■ 1RZ AND 2RZ ENGINES

■ 3RZ-FE ENGINE

258HL01

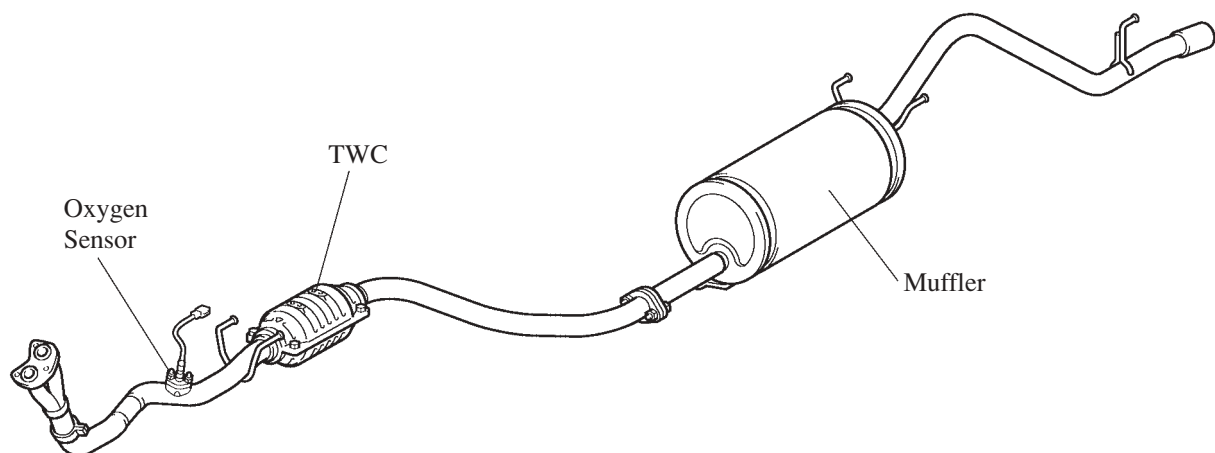
- A thin-wall, ceramic type TWC has been adopted.
- One oxygen sensor has been newly provided in front of the TWC in order to improve the exhaust reduction performance of the TWC through feedback control to the engine ECU.
